Item 4.**Development Application: 130 Joynton Avenue, Zetland - D/2024/514****File No.:** D/2024/514**Summary****Date of Submission:** 9 July 2024. Amended drawings and additional information were submitted on 18 October 2024.**Applicant/ Owner/ Developer:** Deicorp Projects (Joynton Ave) Pty Ltd**Architects:** Fender Katsalidis and Besley & Spreser Architects
(Buildings A, B and C)Candalepas Associates and Lachlan Seegers Architects
(Building groups D and E)**Planning Consultant:** Planning Lab**Design Advisory Panel:** 12 September 2024**Cost of Works:** \$304,040,785.00**Zoning:** The site is zoned MU1 - Mixed Use under the Sydney Local Environmental Plan 2012. The proposal comprises a mixed use development including commercial and residential uses which are permissible with consent in the zone.**Proposal Summary:** Approval is sought for a mixed use development comprising nine new buildings across five development sites including:

The application is referred to the Central Sydney Planning Committee (CSPC) for determination as the cost of works exceeds \$50 million.

Figure 36: Site plan of Building groups D and E with areas of non-compliance highlighted in yellow

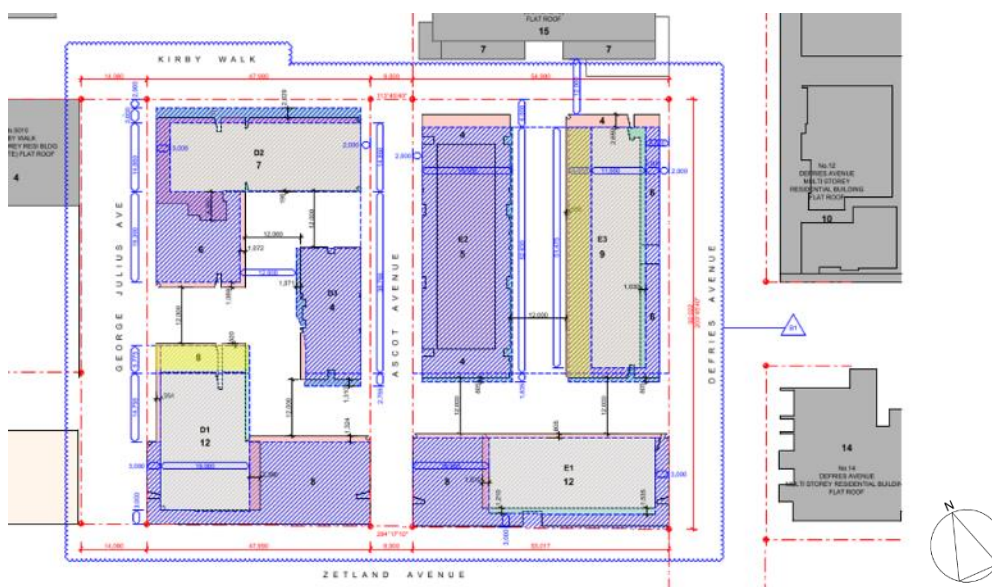
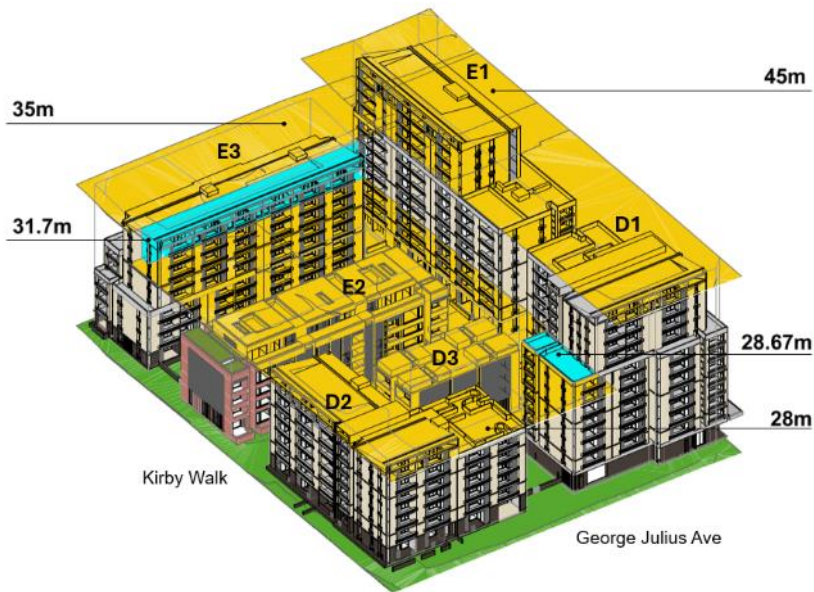
A minor portion of the building on Level 8 has a height of 28.7m, which exceeds the maximum height of 28m by 700mm. This results in a variation of approximately 2.5%. An elevation showing the non-compliance is provided in Figure 38 below.

Figure 39: Building E3 northern elevation, showing the LEP height plane and area of non-compliance in blue

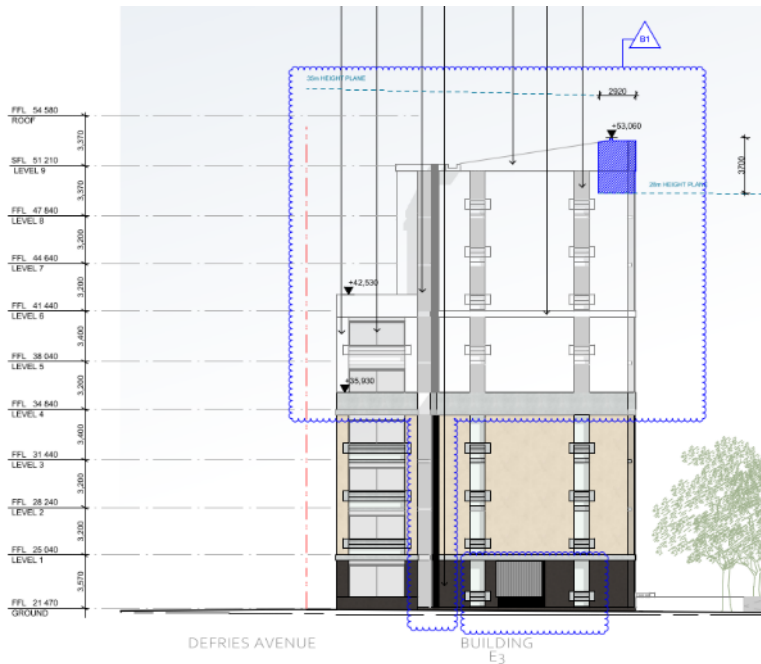
A portion of the building along the western frontage exceeds the 28m height control with a maximum height of 31.7m, resulting in a variation of 3.7m or 13.2%. An elevation showing this non-compliance is provided in Figure 39 below.

Figure 41: Plan of Building D1, showing DCP height exceedance in red

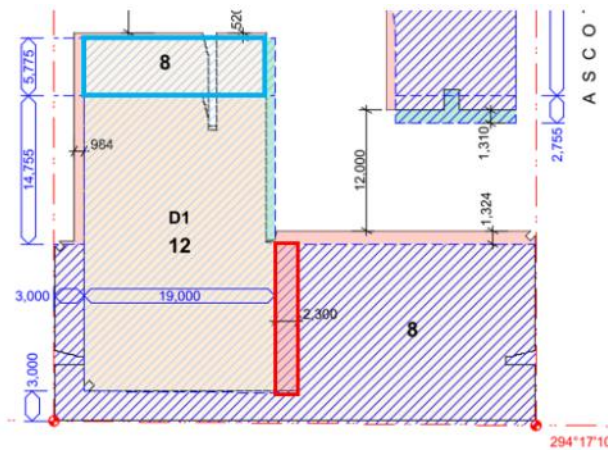
90. A 2.3m portion of the 12 storey form exceeds the DCP height control (outlined in red in Figure 41 below). This is a result of redistributing permissible built form from the northern part of the tower, where 12 storeys are permitted but 8 storeys are proposed (shown in blue in Figure 41 below).
91. The additional height is setback 3m from Zetland Avenue and does not result in adverse environmental impacts.

Figure 42: Plan of Building D2, with DCP height exceedance outlined in red

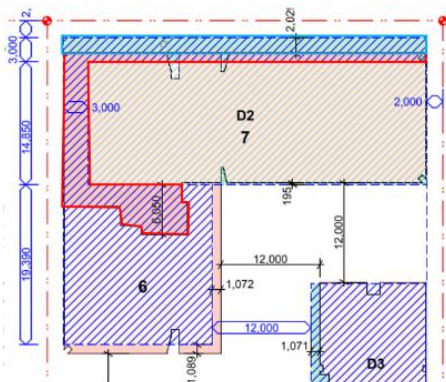
92. The DCP permits a 6 storey street wall to Kirby Walk and George Julius Avenue. The proposal includes a 7 storey street wall to Kirby Walk and part of George Julius Avenue, highlighted in red in Figure 42 below.
93. The additional height along the street wall is acceptable in the context, with a range of building heights along Kirby Walk up to 15 storeys. This building also provides a greater northern setback than required (4m provided instead of 2m) to protect the street trees, which lessens the impact of the additional storey.

Figure 43: Plan of Building E1, with the DCP height exceedance outlined in red

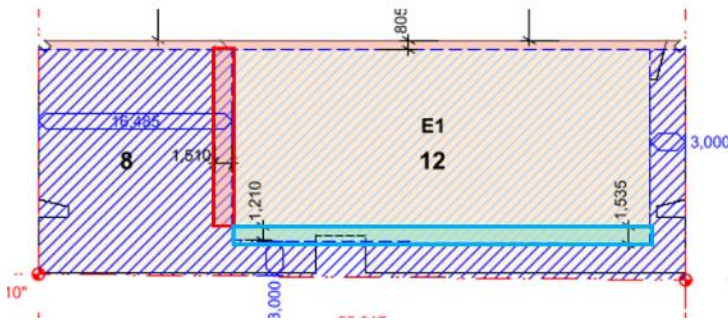
94. A small 1.5m wide portion of the 12 storey form extends west beyond the DCP envelope (outlined in red in Figure 43 below). This is a result of redistribution of permissible built form from the southern edge of the tower (outlined in blue in Figure 43 below).
95. The additional height is setback 4.2m from Zetland Avenue and does not result in visual privacy or overshadowing impacts.

Figure 44: Plan of Building E3, with DCP exceedance outlined in red

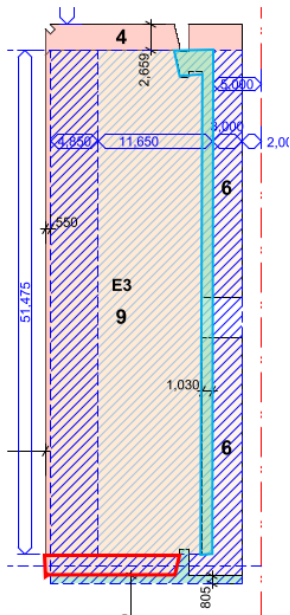
97. The DCP specifies a maximum height of 6 storeys along the southern portion of Building E3. The proposed 9 storey form extends towards the southern frontage of the building, outlined in red in Figure 44 below.
98. The proposal is consistent with the winning competition scheme, which incorporated this massing to reduce overshadowing to neighbouring buildings to the south-east of Building E3. This is achieved by setting back the 9 storey form further back from the eastern boundary. To address visual privacy between Buildings E3 and E1, conditions are recommended to ensure these balconies are treated with sliding screens.

Figure 46: Building D1 corridor requiring a design modification condition, with the recommended configuration outlined in red

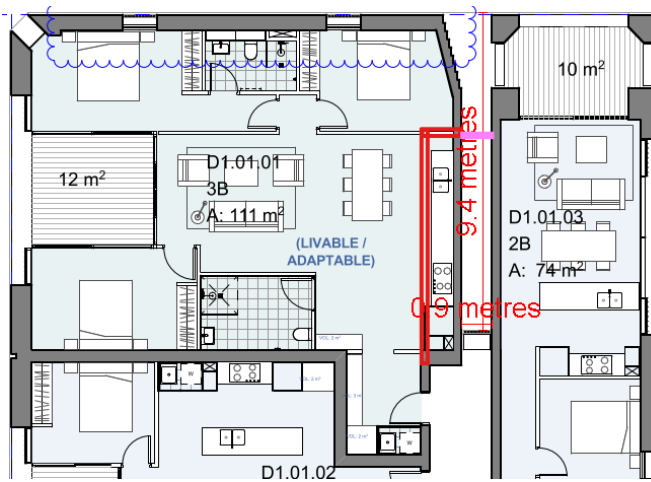
- (a) Further changes are required to the northern end of Building D1 to remove the 9.6m long slot for daylight and shift the window at the end of the corridor north to align with bedroom 2 of apartment D1.01.01. This will require some amendments to the apartment planning and vertical apartment stack above. Refer to Figure 46 below.

Figure 47: Plan showing the additional 5th storey proposed to Building E2

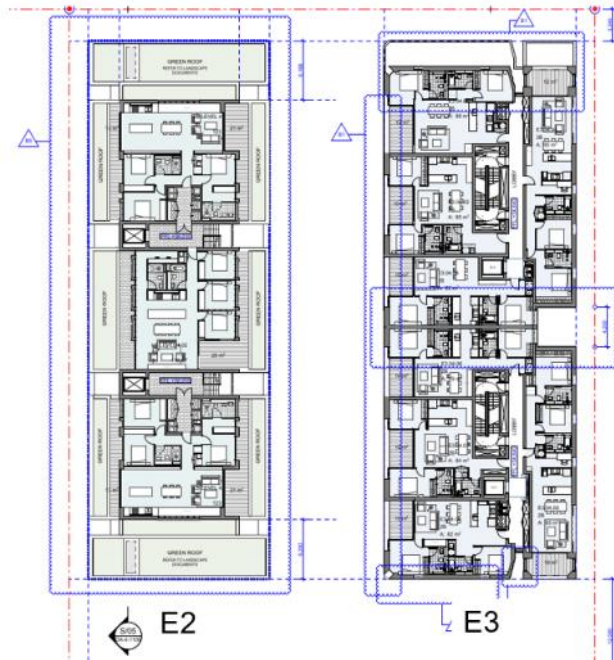
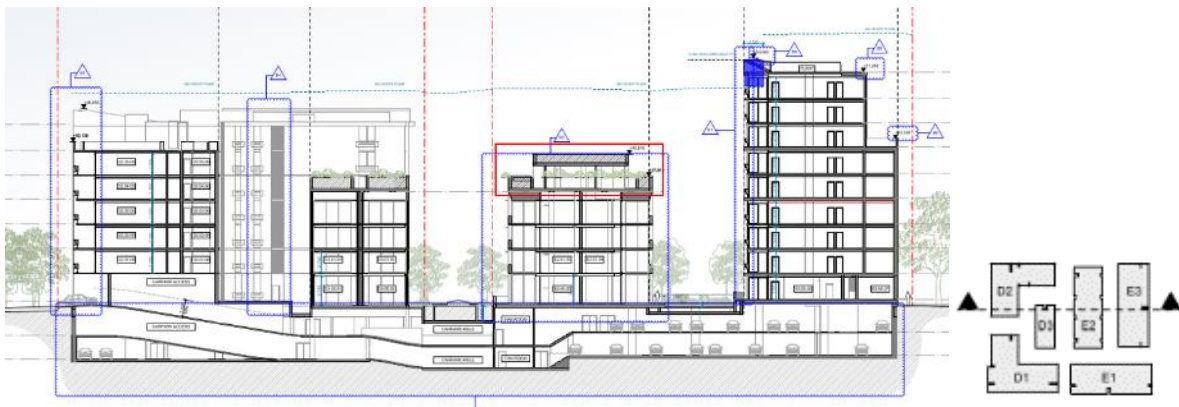
110. The additional storey has been assessed and is supported for the following reasons:

Figure 50: Building E2 and E3 northern setback, showing 3.34m setback proposed compared to the 6m required

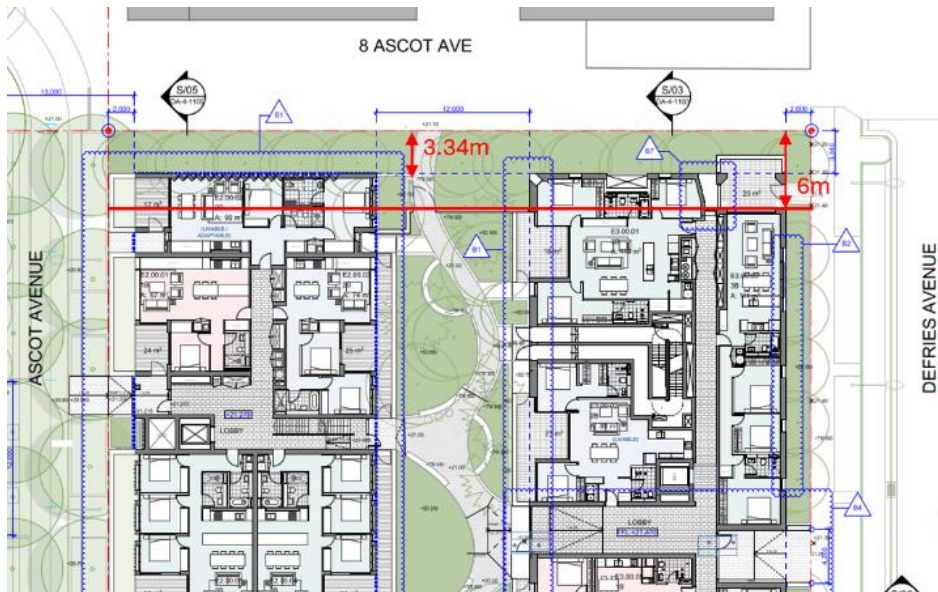
116. The only area of non-compliance with the required landscape setbacks is on the northern edge of Buildings E2 and E3. A 4m landscape setback is proposed where a 6m setback is required by the DCP. Refer to Figure 50 below.

117. The proposed 3.34m setback in this location is acceptable as it achieves the recommended 12m separation from the northern neighbour at 8 Ascot Avenue for Levels 1-4, which complies with the ADG. The 3.34m setback is proposed for Levels 1-4 only, with upper levels further setback for additional building separation.
118. Overall, the development provides adequate landscape setbacks and ground floor interfaces across the development in accordance with the objectives of the SDCP 2012.

Figure 55: Originally submitted vs amended building separation between Building E3's northern frontage and 8 Ascot Avenue

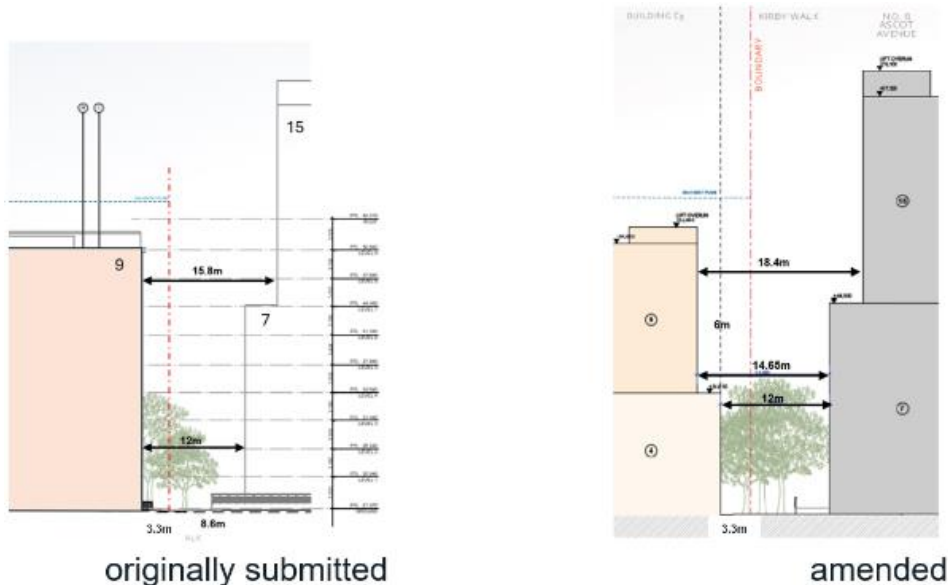
- 131. The plans originally submitted with the application proposed an approximately 3.3m setback from the northern boundary for Buildings E2 and E3. This was an issue particularly for Building E3, which was 9 storeys up the entire northern frontage. This setback was not supported as it did not adequately address the recommended ADG building separation distances and resulted in an overbearing form.
- 132. Amended plans were submitted incorporating an additional 6m setback from the northern boundary above Level 4 for Building E3, resulting in building separations depicted in Figure 55 below.

133. Consideration of Buildings E2 and E3 against the ADG design criteria for building separation is summarised below:
- (a) Building E2:
 - (i) This building is 4 storeys to the northern boundary. Therefore, the 12m separation to 8 Ascot Avenue complies with the ADG design criteria.
